UPDATE
URGENT FIELD SAFETY NOTICE
MEDICAL DEVICE CORRECTION

MAQUET CARDIOSAVE hybrid and MAQUET CARDIOSAVE rescue

Product Code/Part Number:	0998-XX-0800-XX
Distributed Affected Lot Number:	All
Distribution Dates:	Since March 6, 2012

Figure 1 – Monitor Display (1 – Helium Indicator)

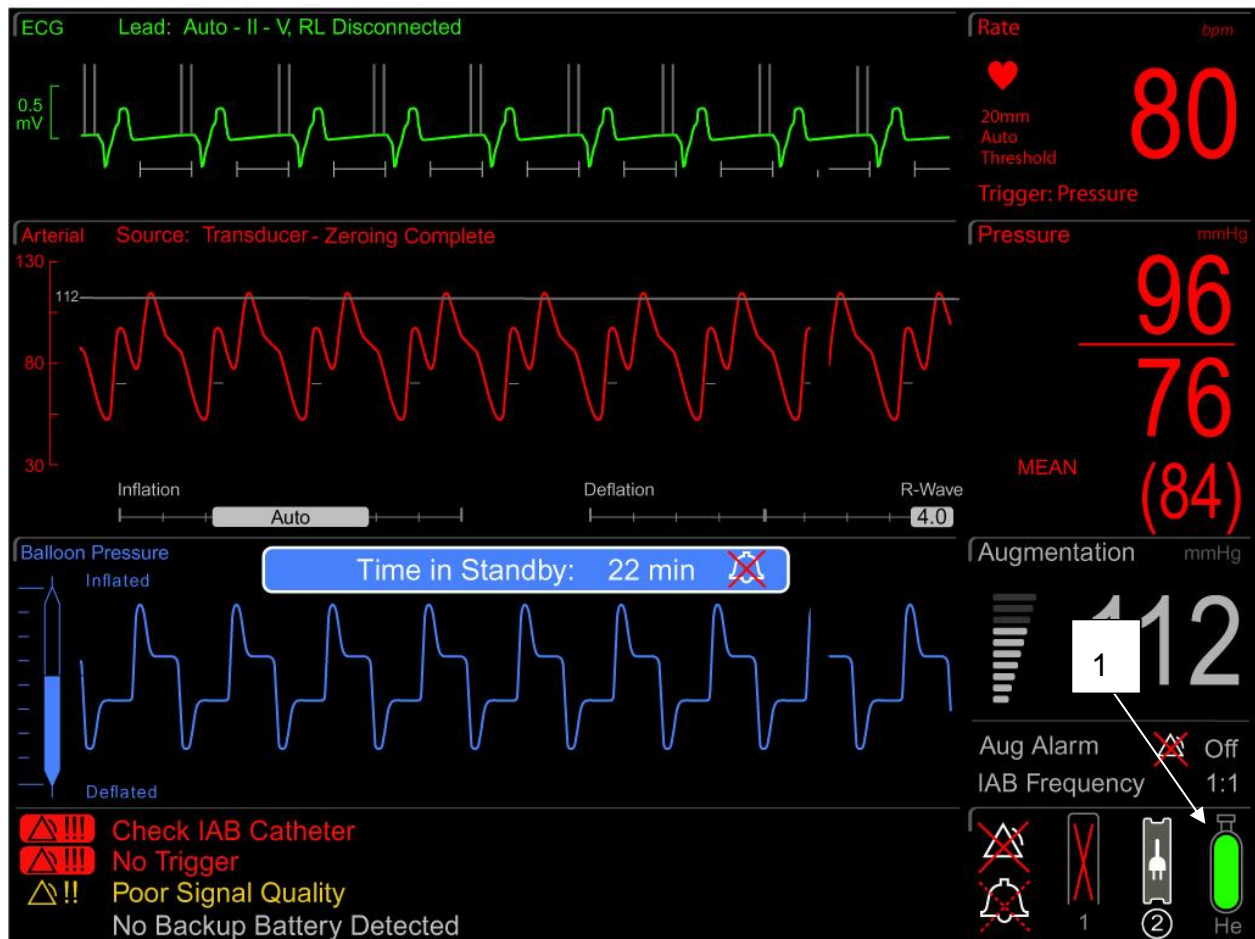
During Electromagnetic Compatibility (EMC) testing at an external lab, Getinge personnel determined that in the presence of some radiated RF disturbances, the Helium Indicator on the Cardiosave IABP (refer to Figure 1) would intermittently over-report the remaining Helium Capacity. Once the disturbance was removed the Helium indicator always fully recovered within 10 seconds to display the proper level without any over-reporting.

Getinge’s investigation revealed that the over-reporting of Helium Capacity would intermittently occur at frequency ranges between 80 MHz – 1 GHz. Potential sources of interference include: radio communication, cell phone, Wi Fi, RFID equipment and equipment that does not meet current electromagnetic compatibility standards.

Datascope/Getinge is developing a hardware correction to address this issue. A Datascope/Getinge service representative will contact you to schedule the installation of the correction when available. This work will be done at no cost to your facility.

Figure 2 – Top Panel (1 – Mechanical Helium Gauge)

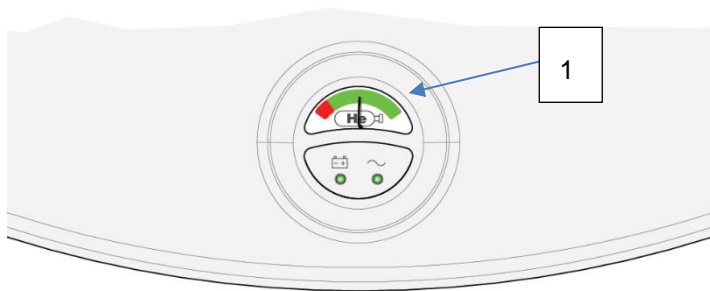
Since the mechanical gauge is not influenced by EMC, view the mechanical gauge on the Cardiosave Top Panel (See figure 2) to assess remaining helium capacity in case of suspected EMC disturbances.
